City of Linden
Union County, New Jersey
Department of Community Services
Division of Engineering

May 7, 2020

Re: *Application No. SP 1111-19*
Zone: LI and RPZ Overlay
Nicholas Patti Holdings LLC.
Site Plan Approval
Block 568 Lot Nos. 2, 3, & 4
37 West 21st Street, Linden, NJ

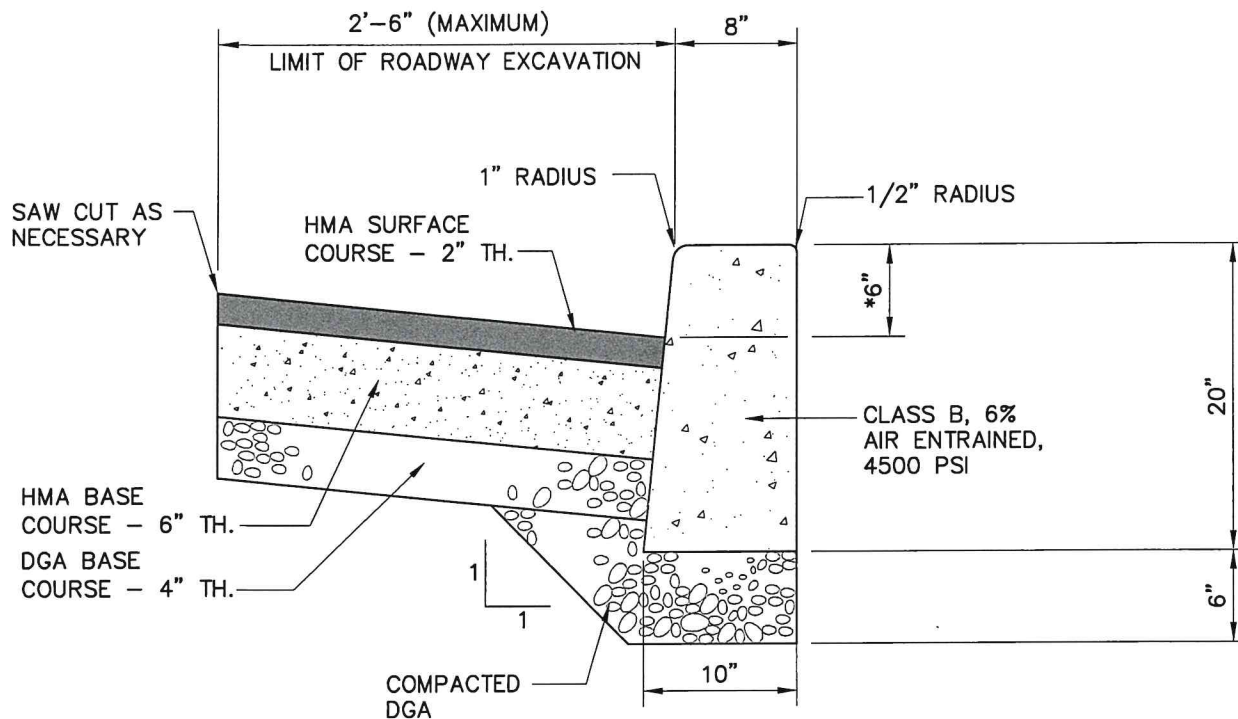
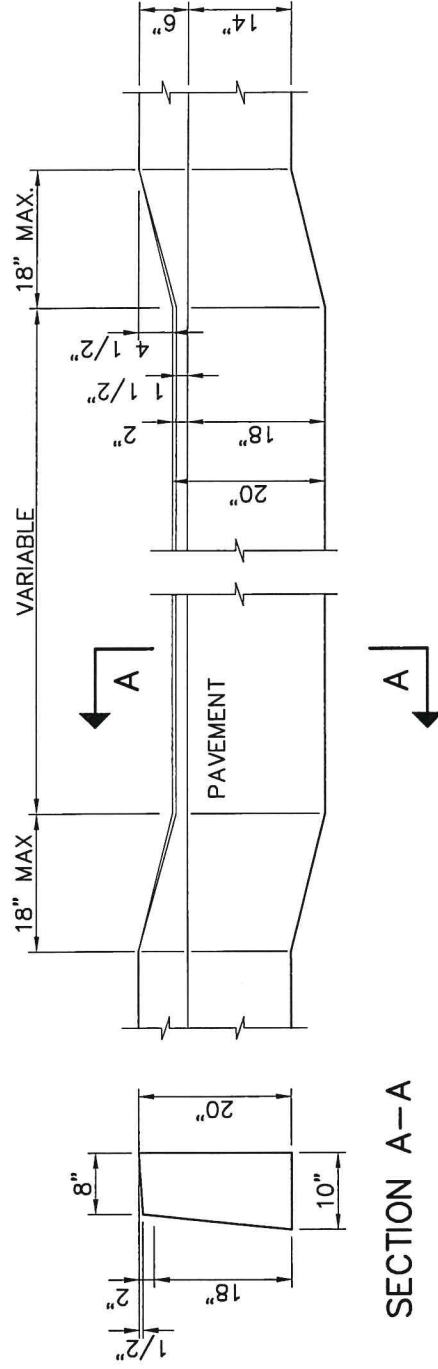
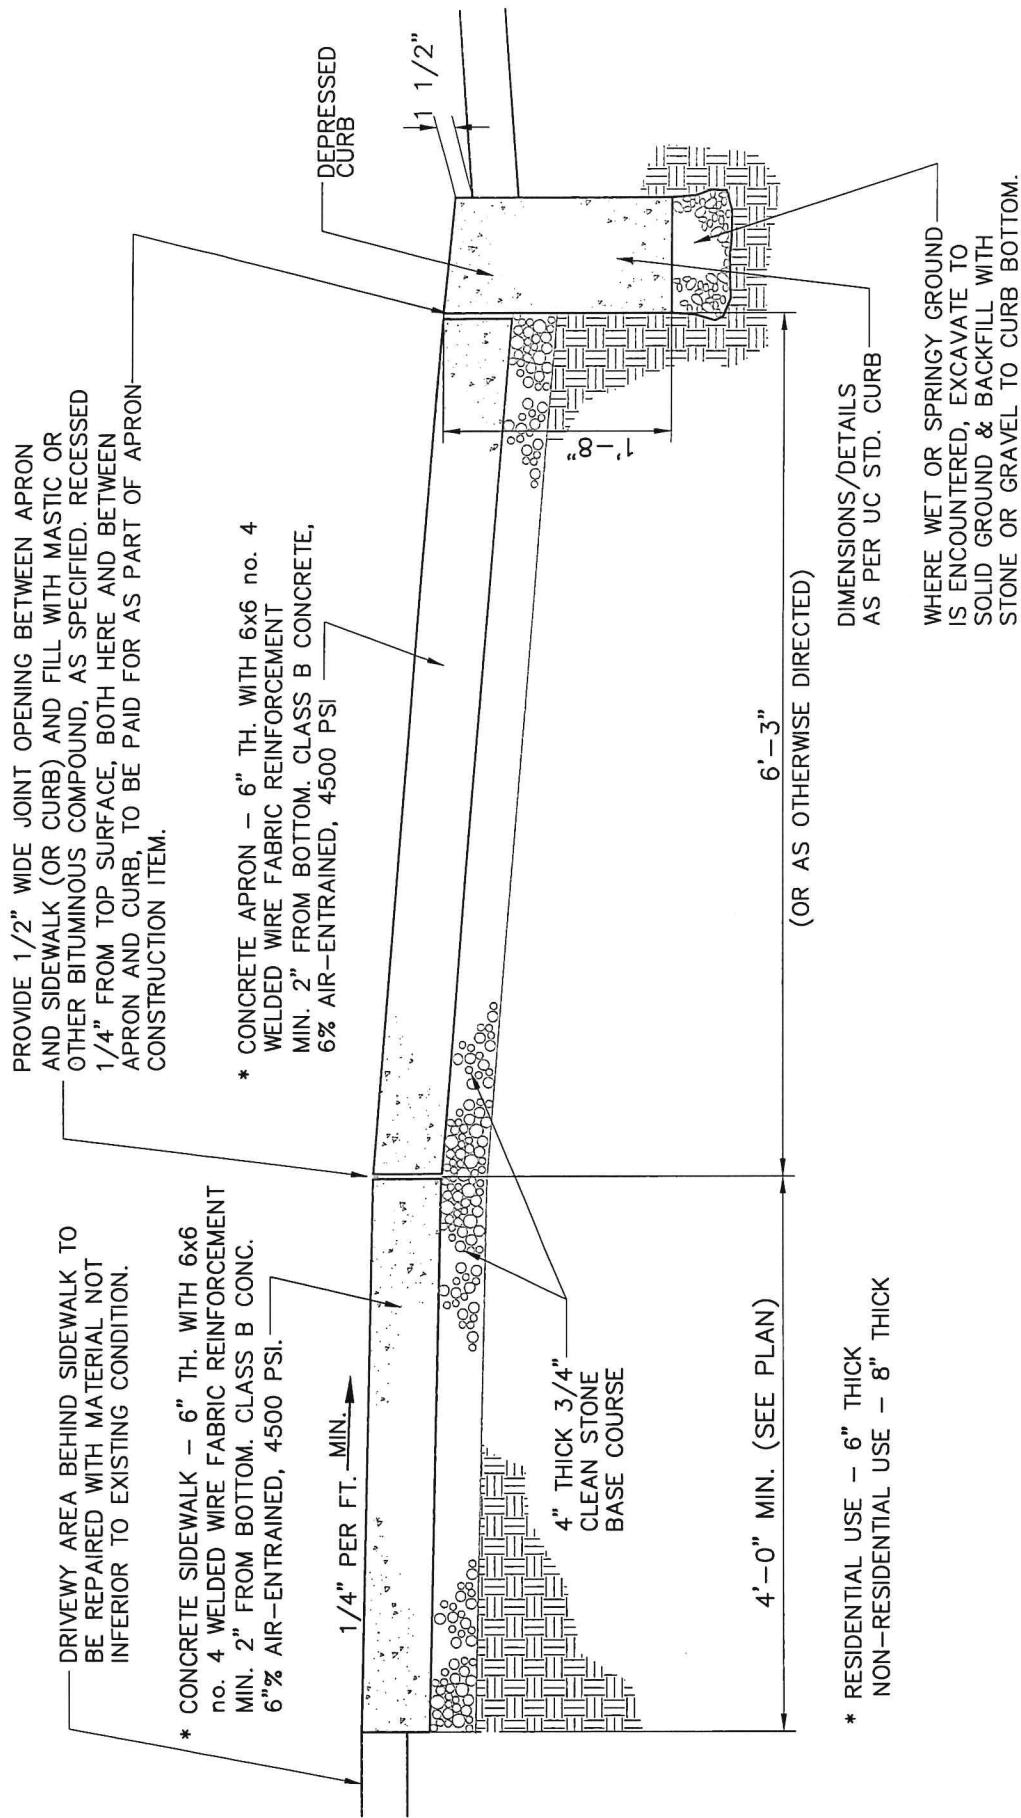
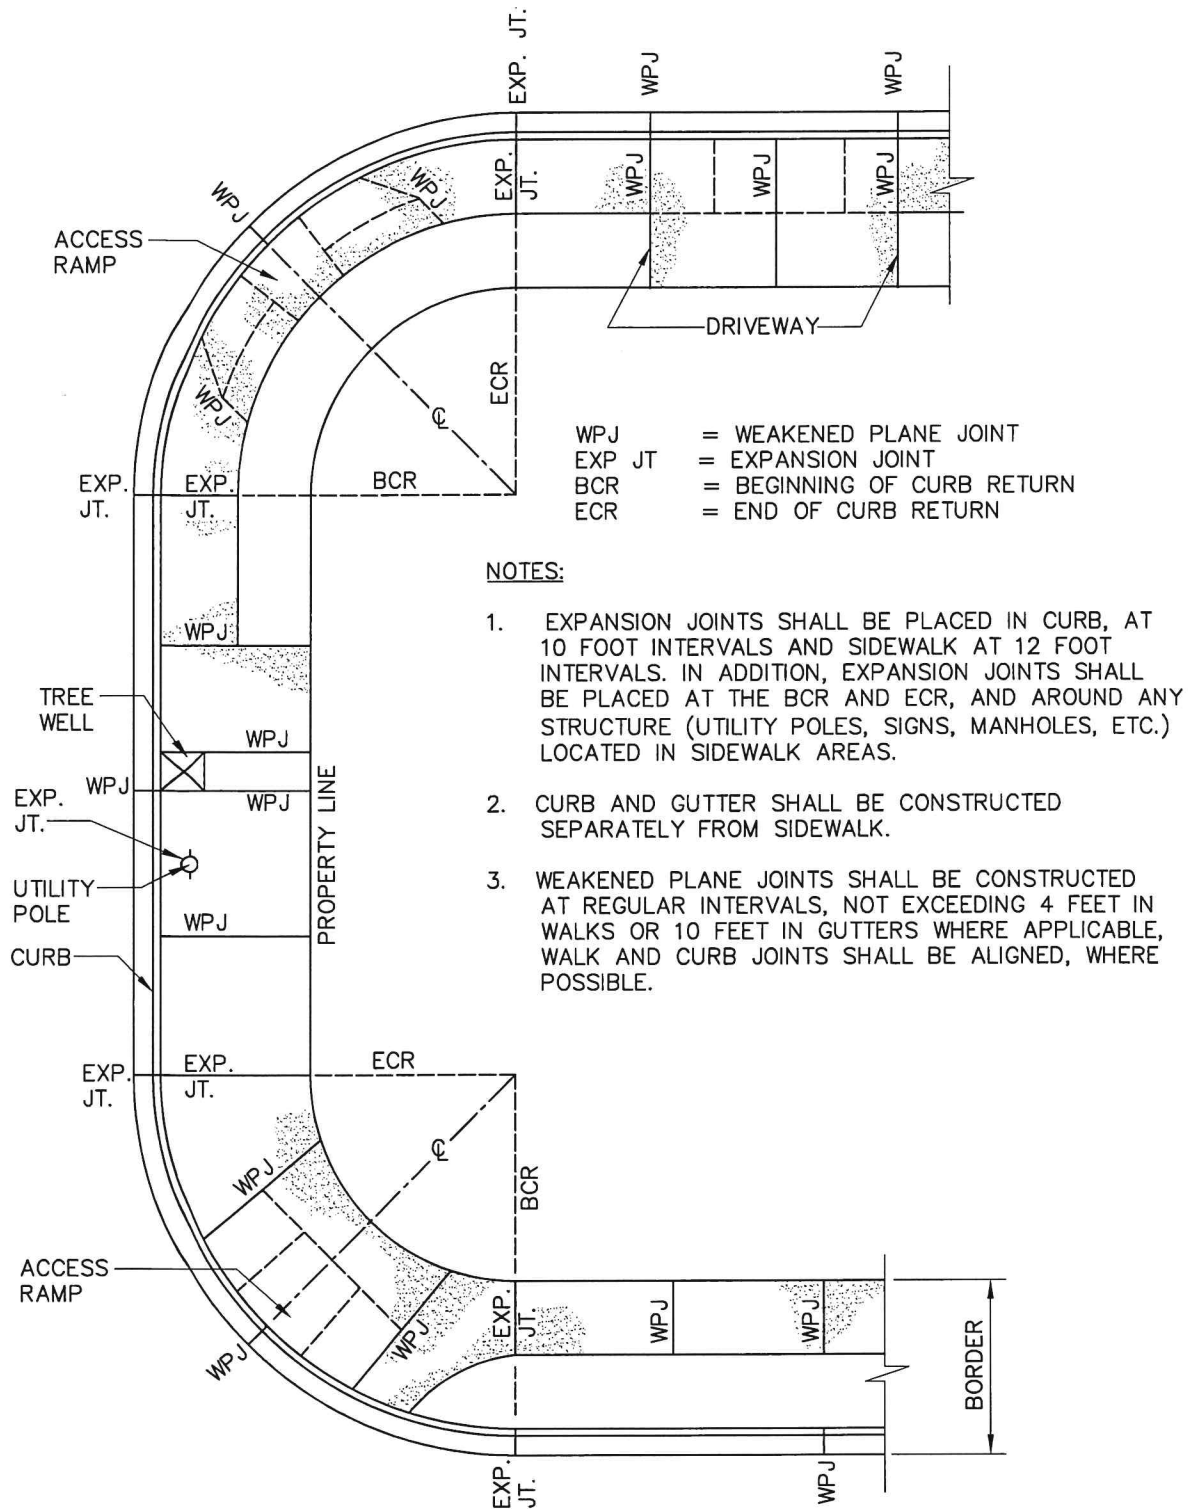
Applicant's Engineer to make appropriate revisions to entire drawing set;
 - The concrete curb detail shall be as per the City's standard. Transverse joints ½" wide shall be placed 10 ft. apart in the curb. Copy attached for your reference;
 - The following construction details shall be added to the plans:
 - Typical Roadway Excavation & Restoration at Curbs;
 - Depressed Curb at Driveways;
 - Concrete Driveway Apron, Typical Section;
 - Hot Mix Asphalt Pavement Trench Restoration;
 - Curb and Sidewalk Joints.
- **Sheet S1 of Set** – This sheet is incomplete and needs to be revised to show dimensions of all four sides of the proposed building, including any openings and façade types. Such attributes are typically represented on an Architectural Drawings, signed & sealed by a Licensed Architect?
